DOOR FALLING DOWN WHEN OPENED. SLIDING HINGE FOR HEAVY DOOR PANELS.**DESCRIPTION:**

Sliding hinge details

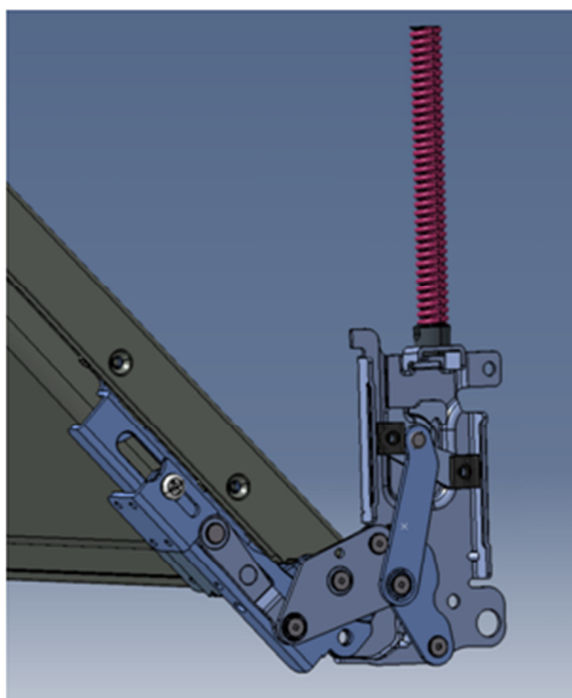
Customers could claim about the uncertain door balancing. Build-in Dishwasher's door falls down when opened. Problem can be caused by particularly heavy door panel.

New sliding door hinge is available - as a spare part only - to be used on fully built-in 60cm DIVA2 and DOROTEA dishwashers that are fitted with particularly heavy door panels.

The weight of the panel can be between 7 kg and 15 kg.
